Addendum 001 – Recommendations for Liquefied Gas Carrier Manifolds, Second Edition (2018)

Chapter 3: Protection from Cargo Spill

p.20, 3.3 Drip Trays

Figure Ad1: Minimum depth of manifold drip tray

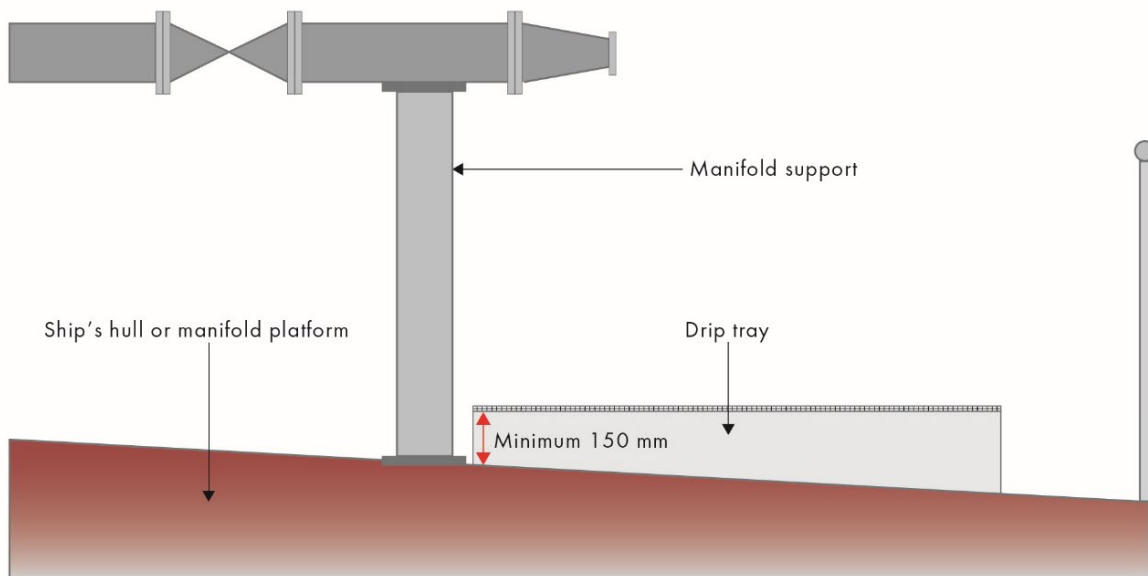
Original sentence:

"A drip tray should have a minimum depth of 300mm"

After the original sentence, please add:

'To accommodate different design options, the minimum depth of a drip tray may be 150 mm along the inner edge as shown in Figure Ad1 below. The total volume of the drip tray should be equivalent to the volume calculated using a minimum depth of 300 mm.'
